Date: November 1, 2022

Subject: ADDENDUM #3

Project: Transition Building
(T99) Addition

Project No: 220081

TRANSITION BUILDING ADDITION

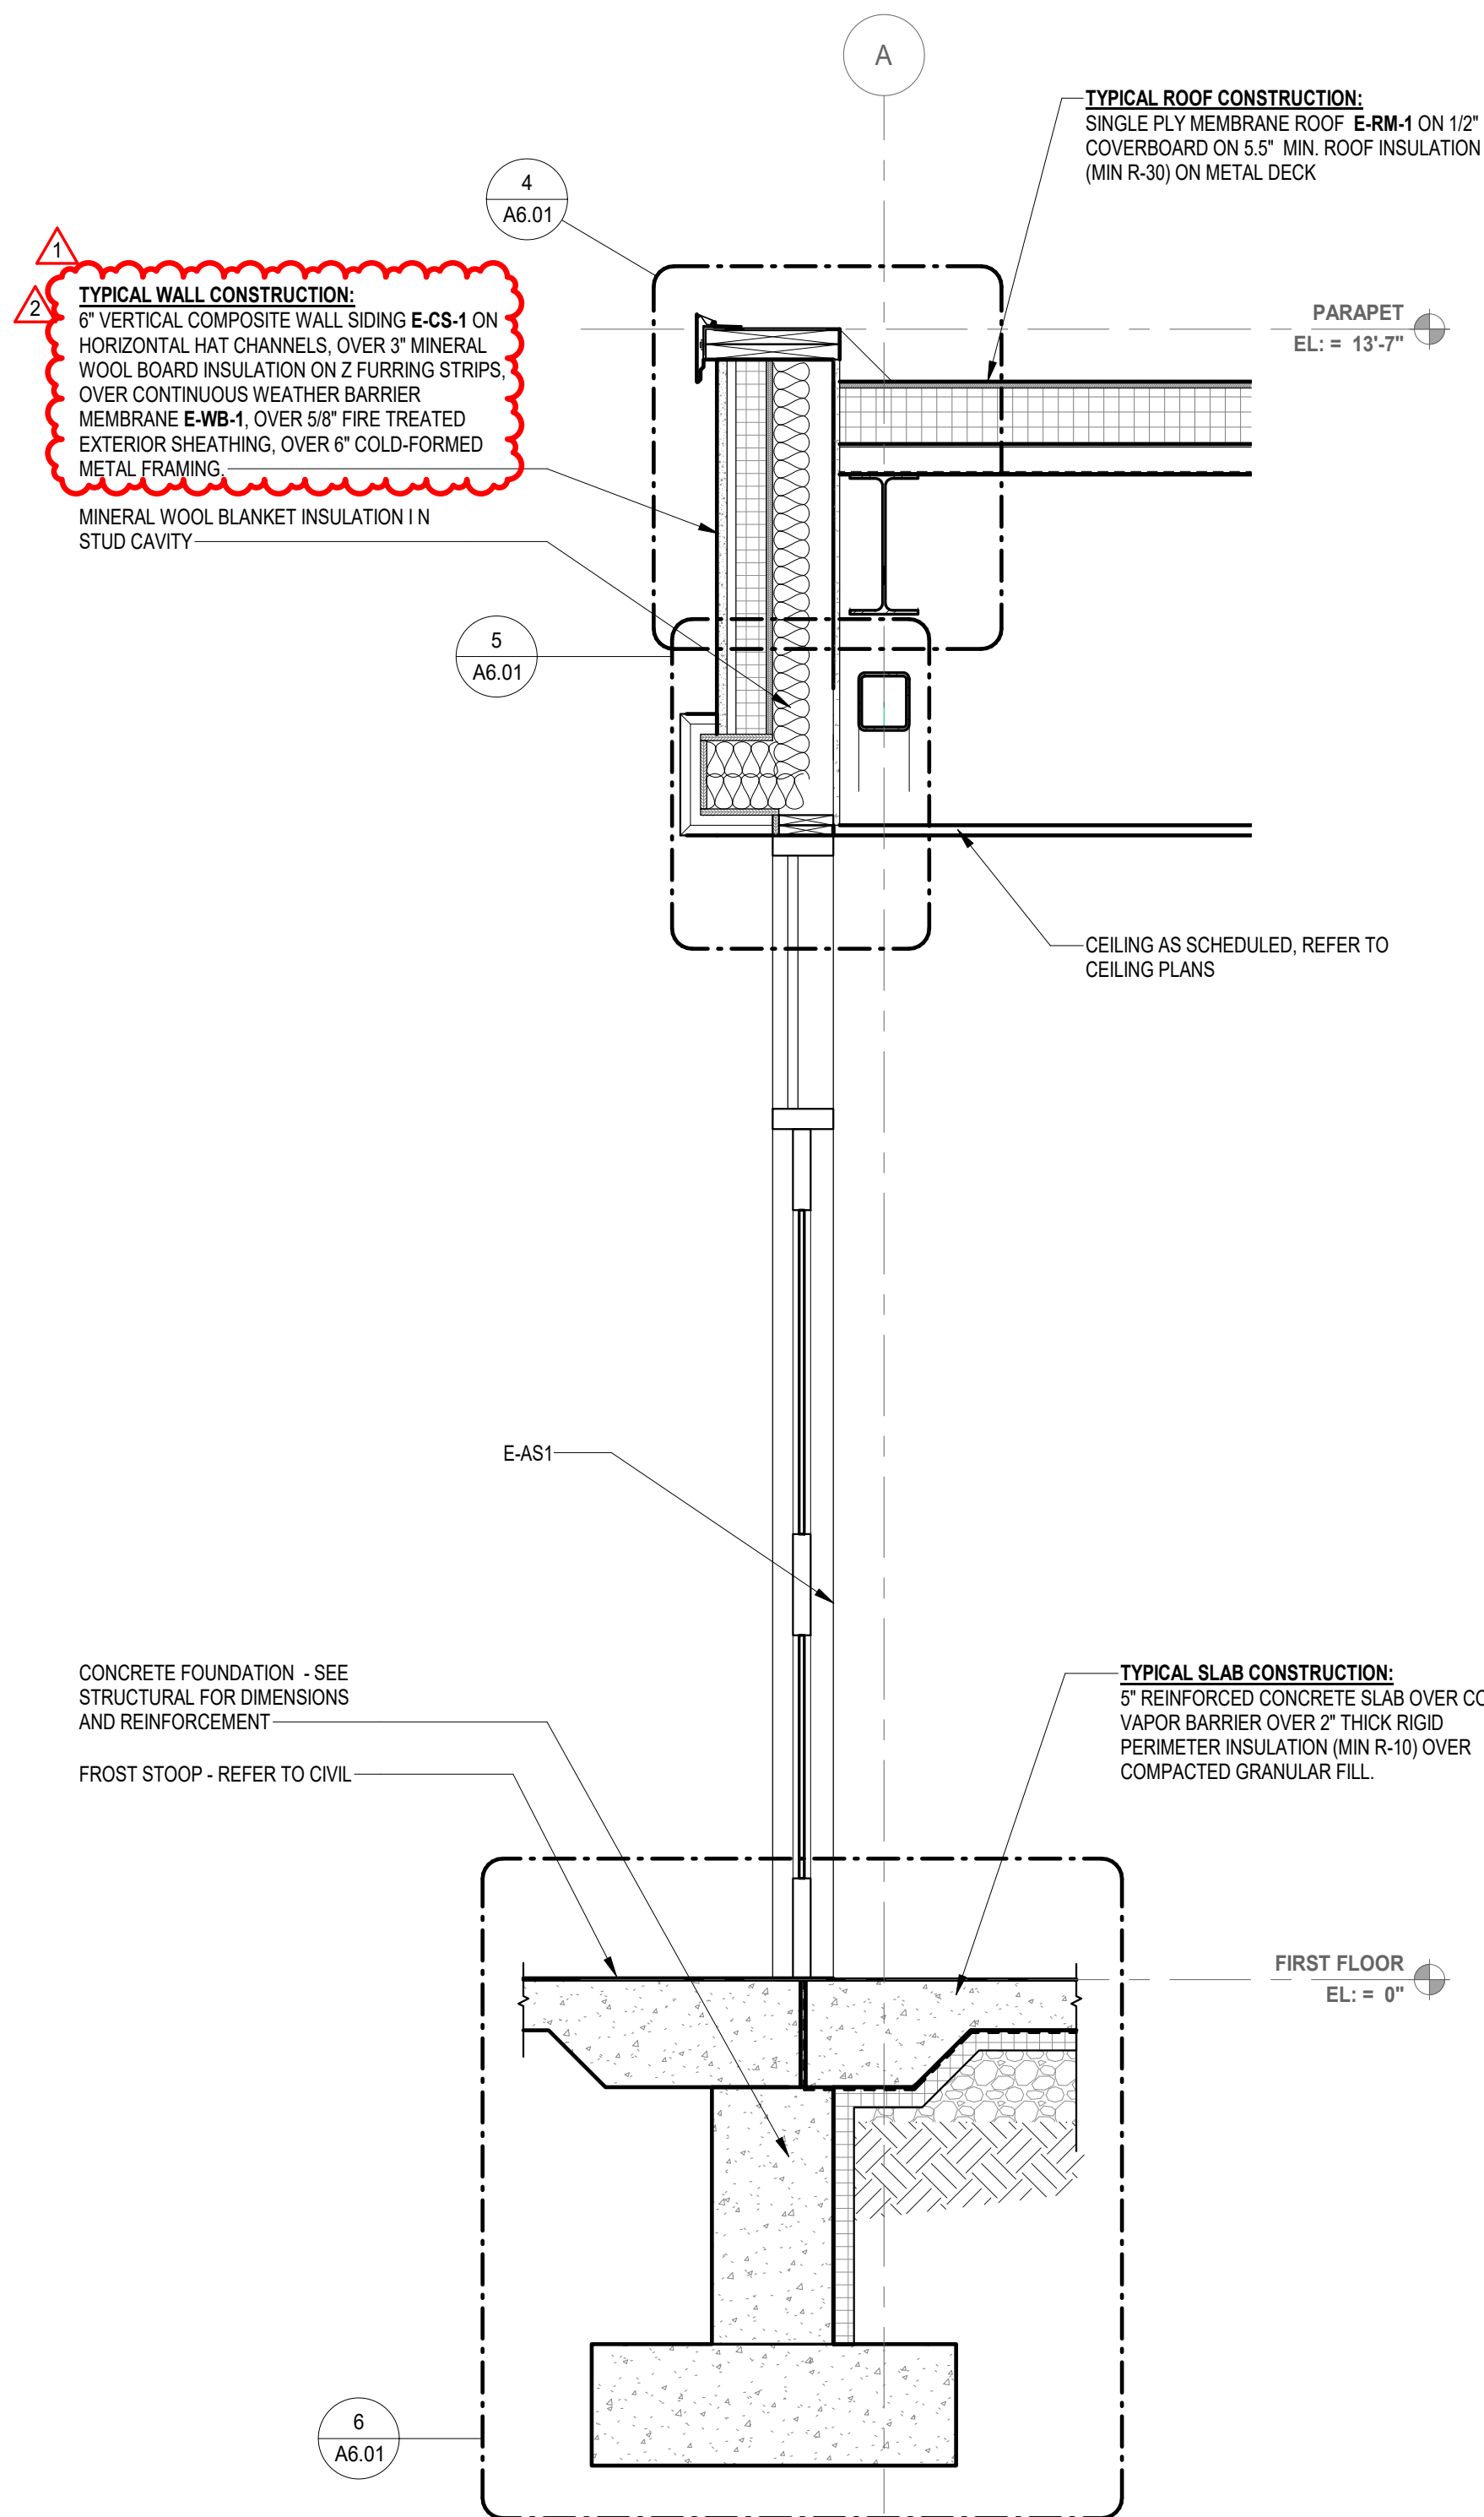
1. ***SHEET A5.00*** (FULL SIZE SHEET REISSUED)
 - Revised "horizontal punched hat channels" to "horizontal hat channels".
2. ***SHEET A5.01*** (FULL SIZE SHEET REISSUED)
 - Revised "horizontal punched hat channels" to "horizontal hat channels".
3. ***SHEET A6.01*** (FULL SIZE SHEET REISSUED)
 - Revised "horizontal punched hat channels" to "horizontal hat channels".
4. ***SHEET A6.02*** (FULL SIZE SHEET REISSUED)
 - Revised "horizontal punched hat channels" to "horizontal hat channels".

C2.00

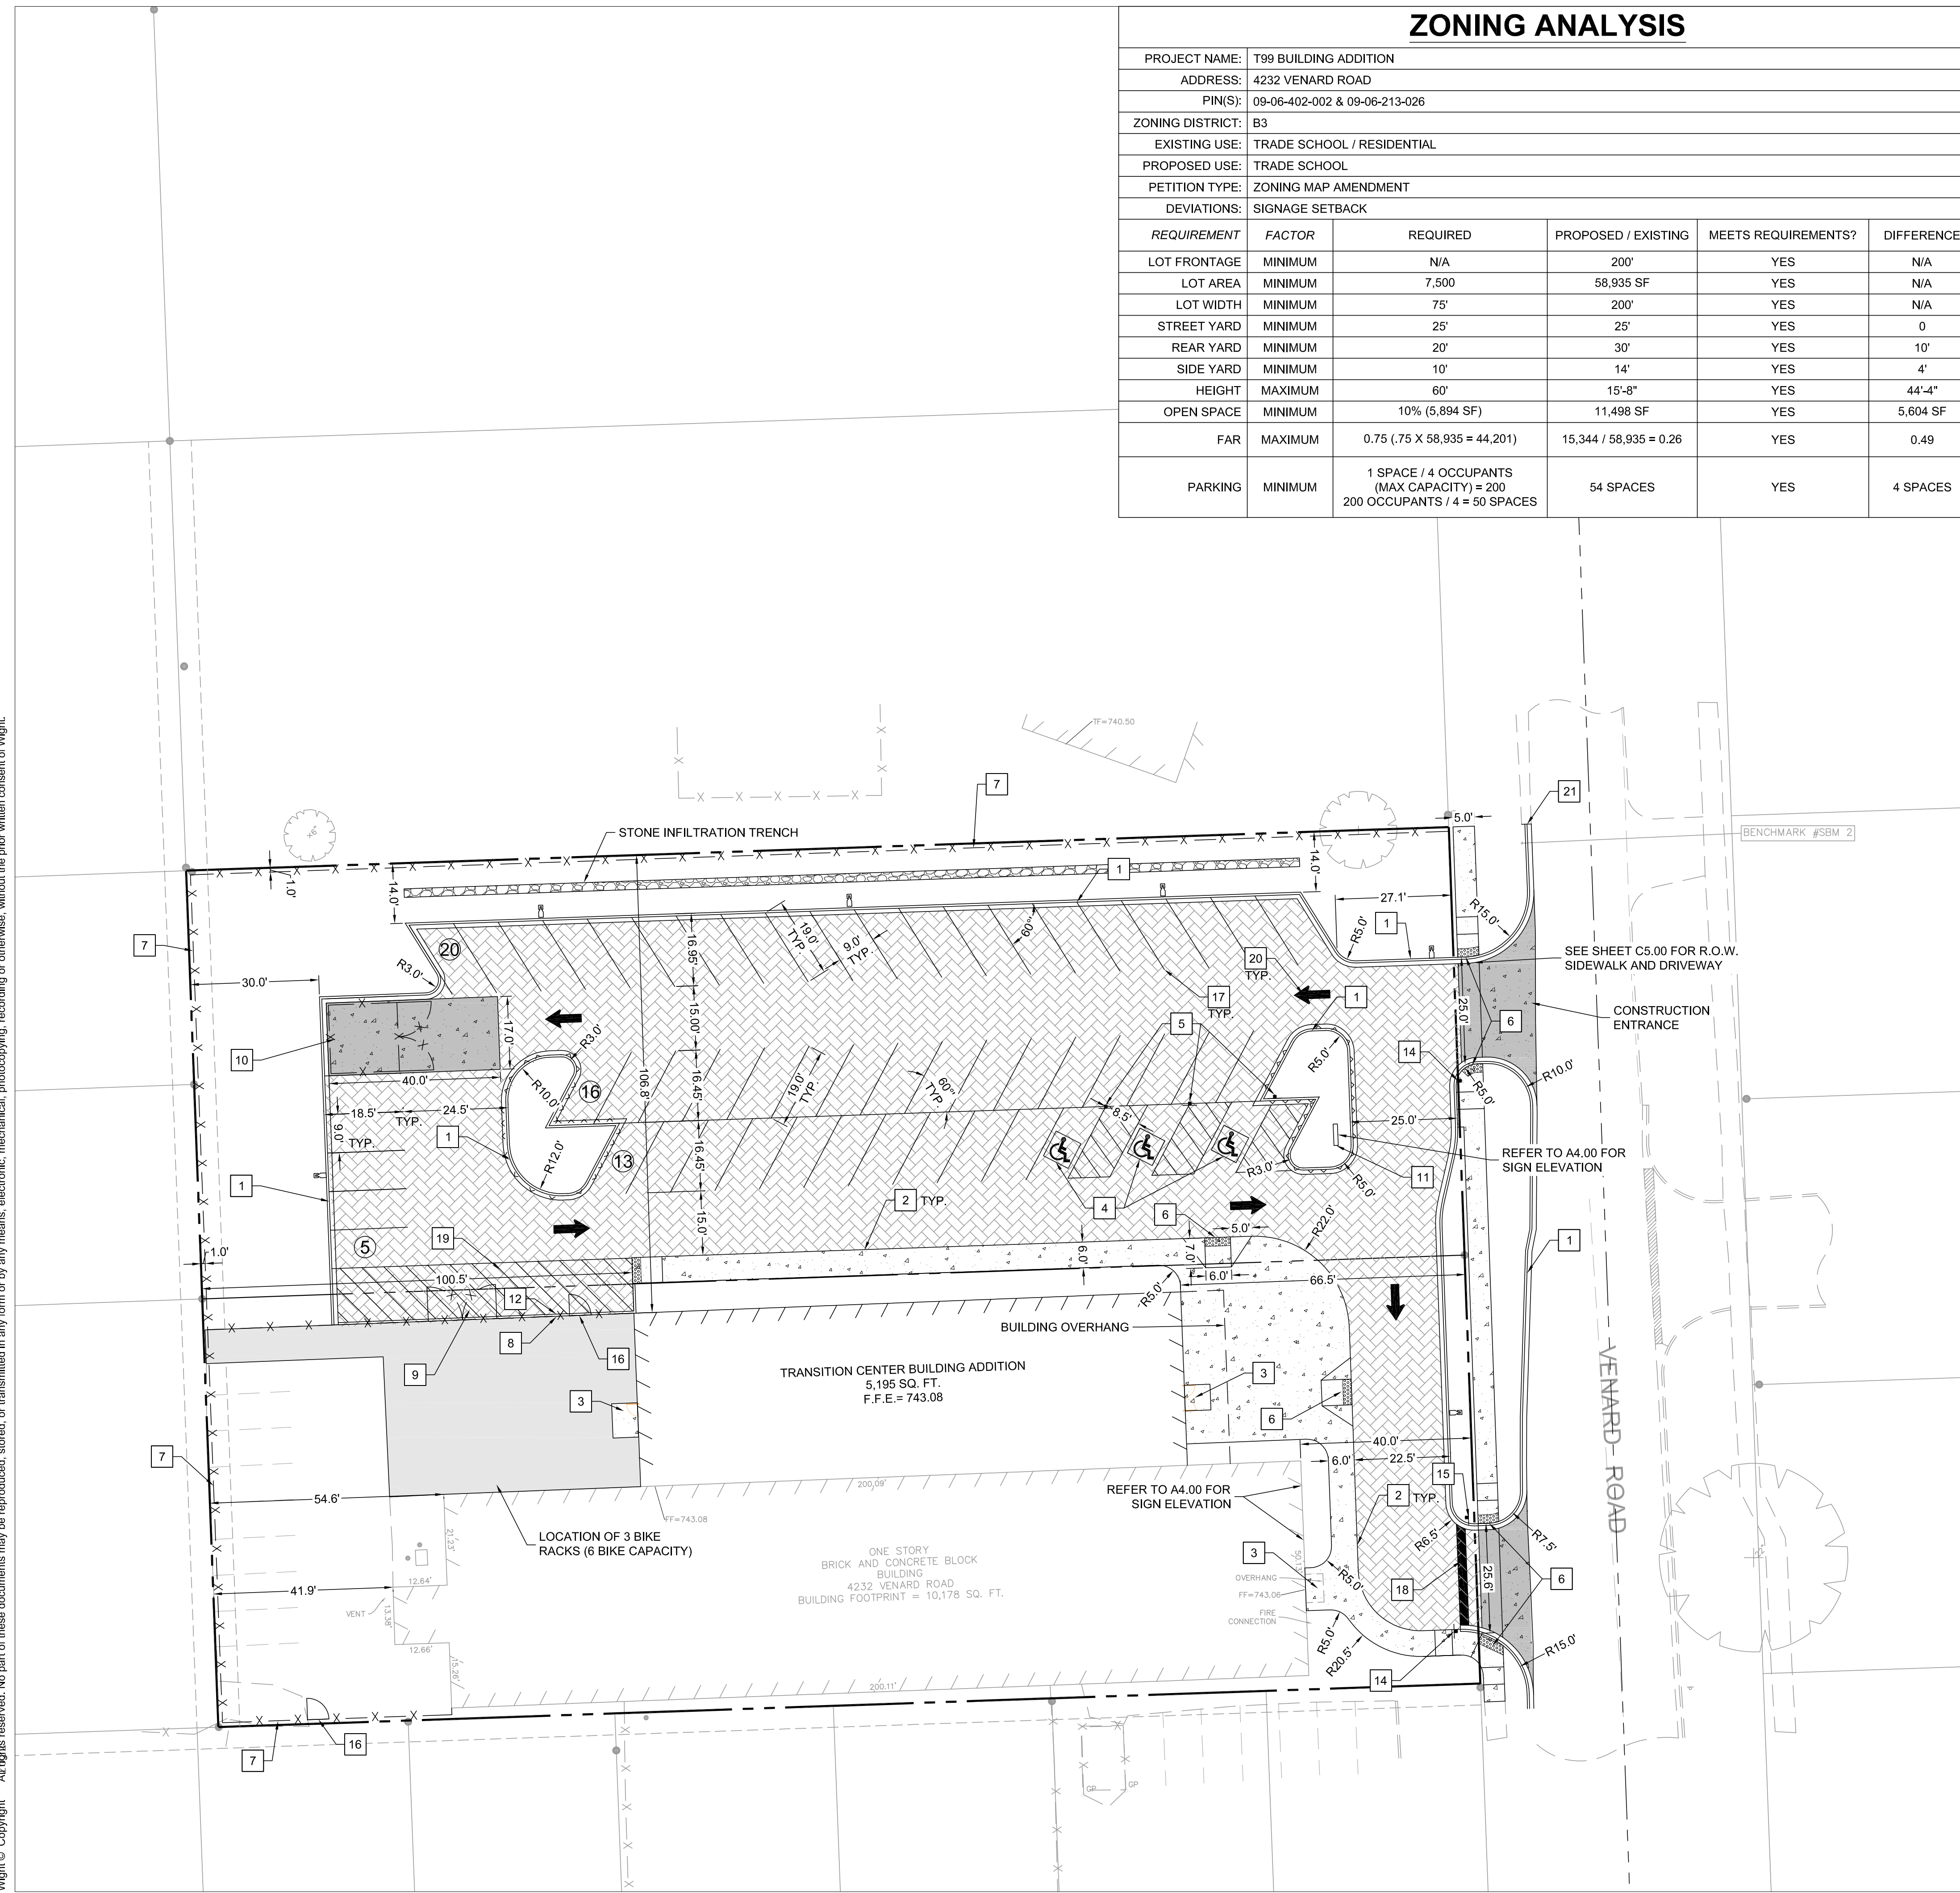
5. ***SHEET C2.00*** (FULL SIZE SHEET REISSUED)
 - Keynote 13 has been revised.
 - Notes 6 and 7 have been added.

C3.00

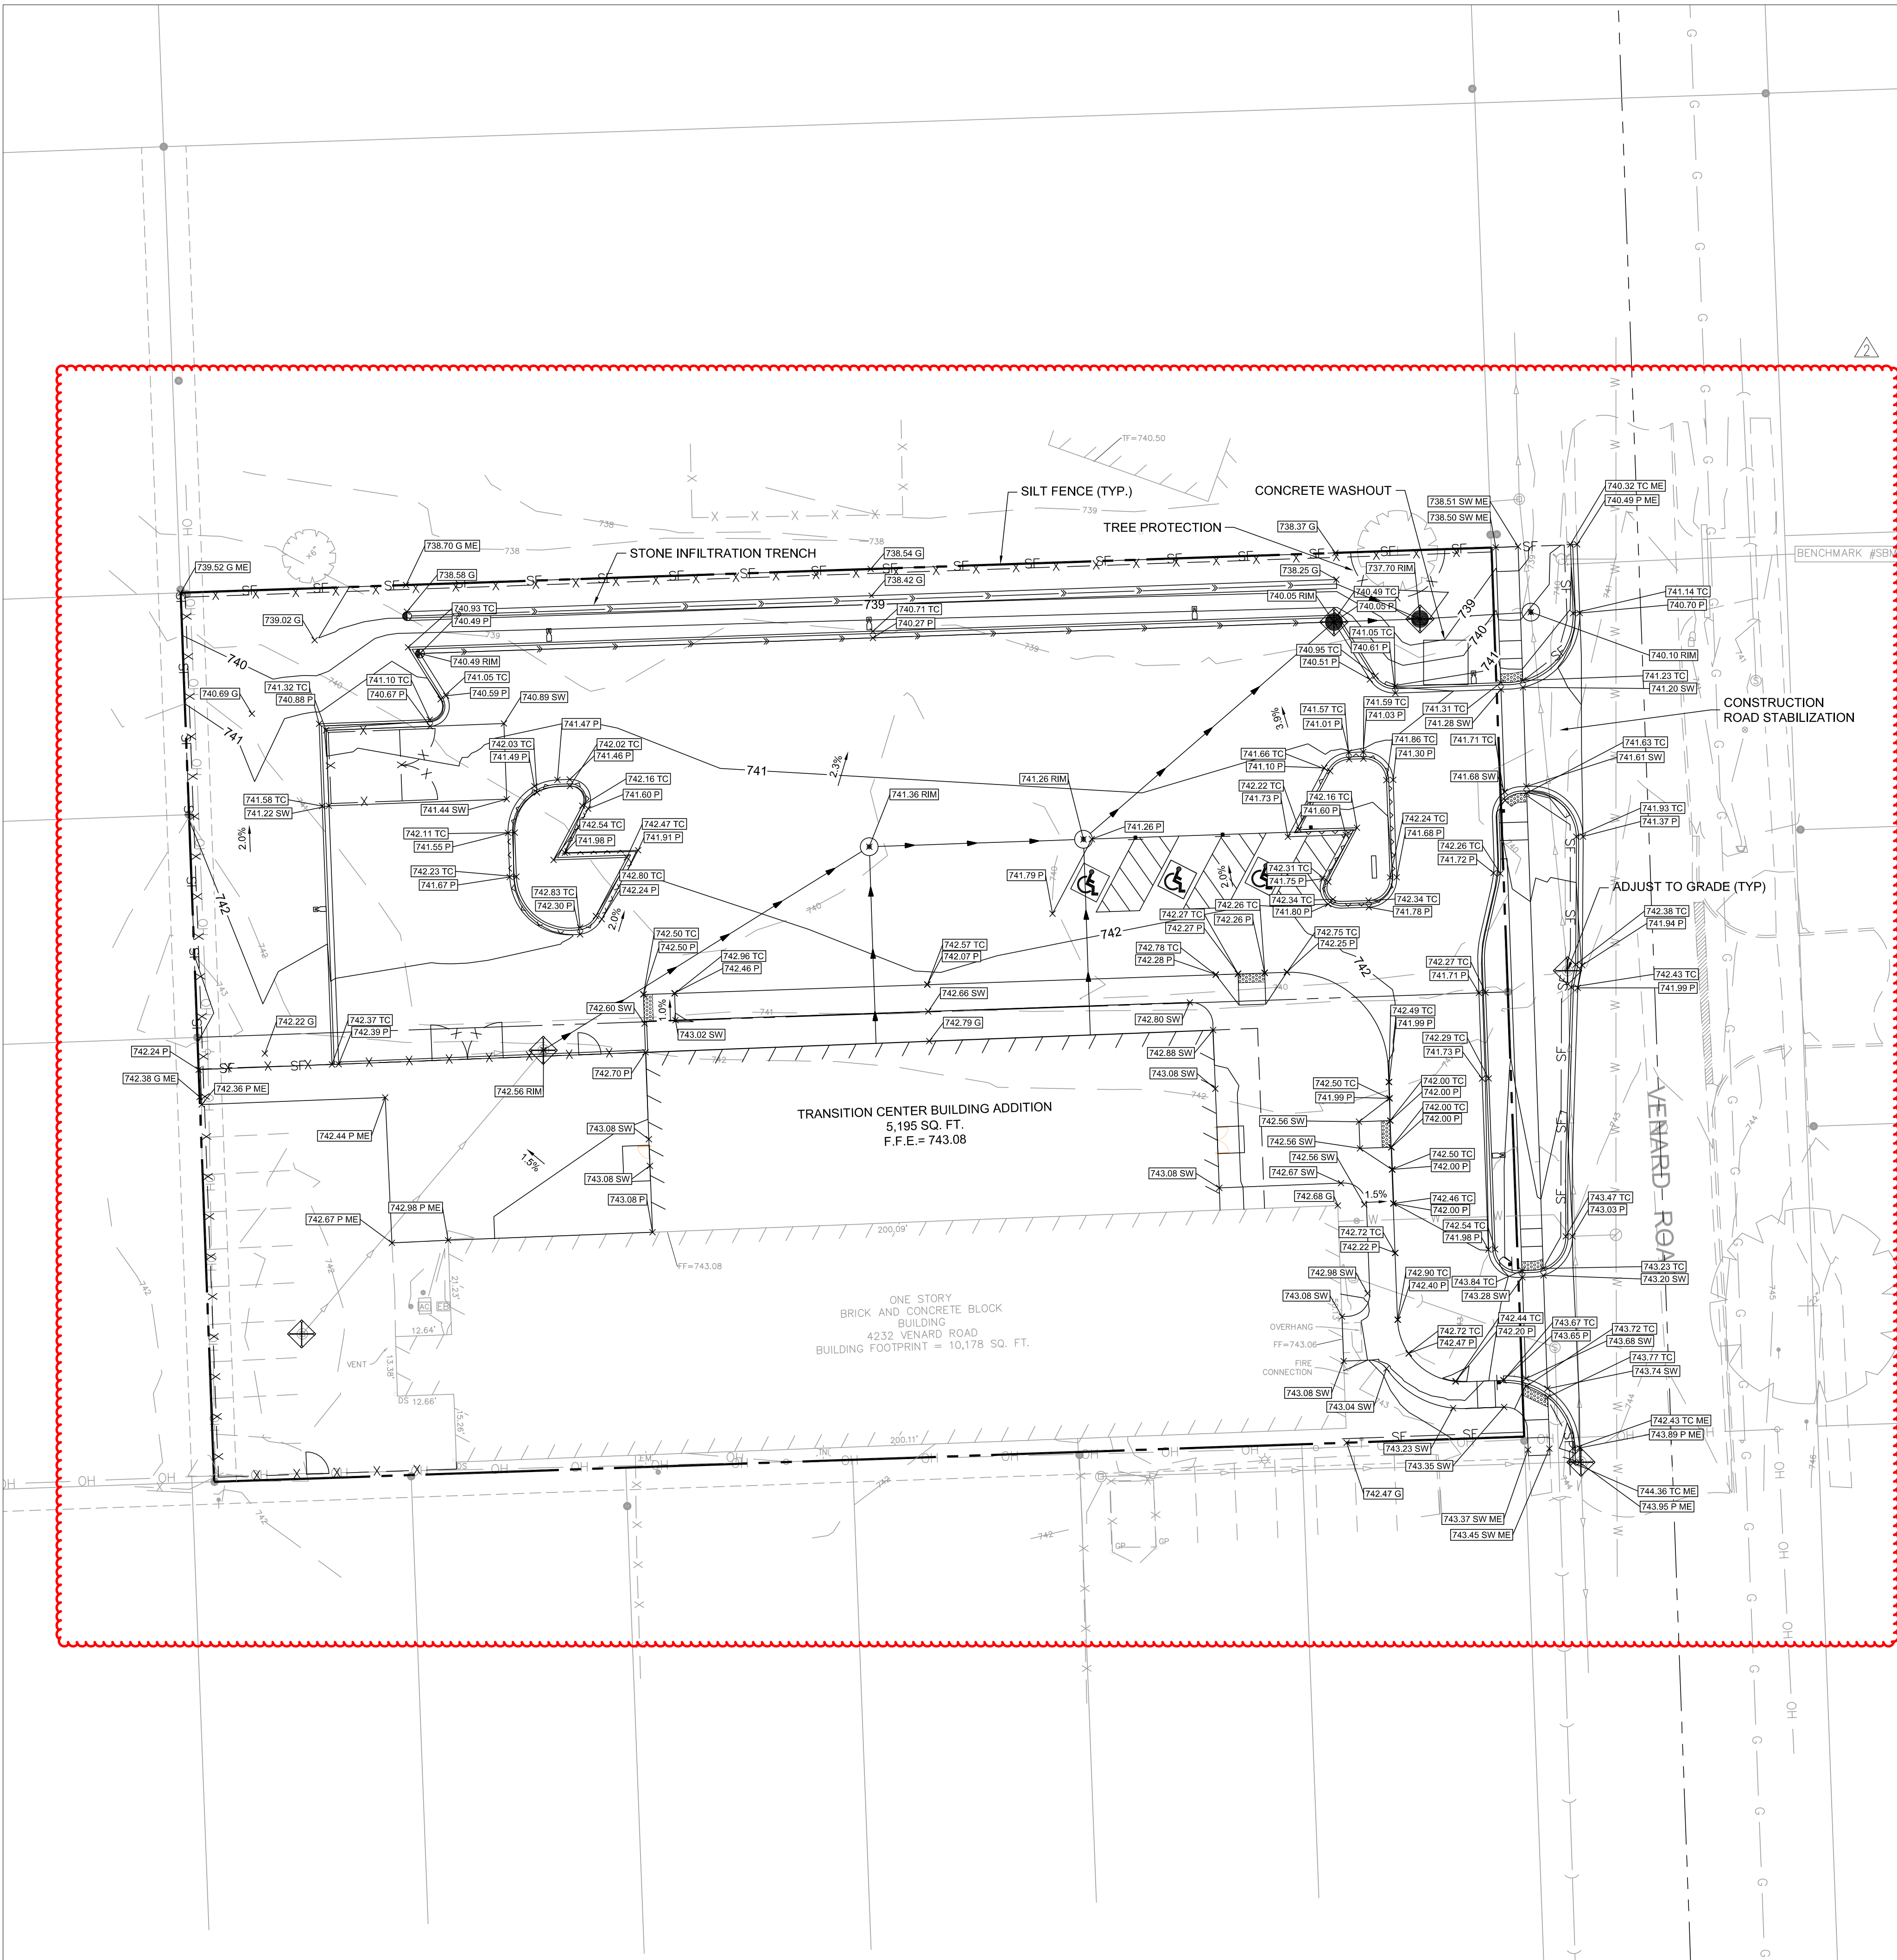
6. ***SHEET C3.00*** (FULL SIZE SHEET REISSUED)
 - Grading has been revised.
 - Erosion control measures have been added.
 - The notes have been updated.
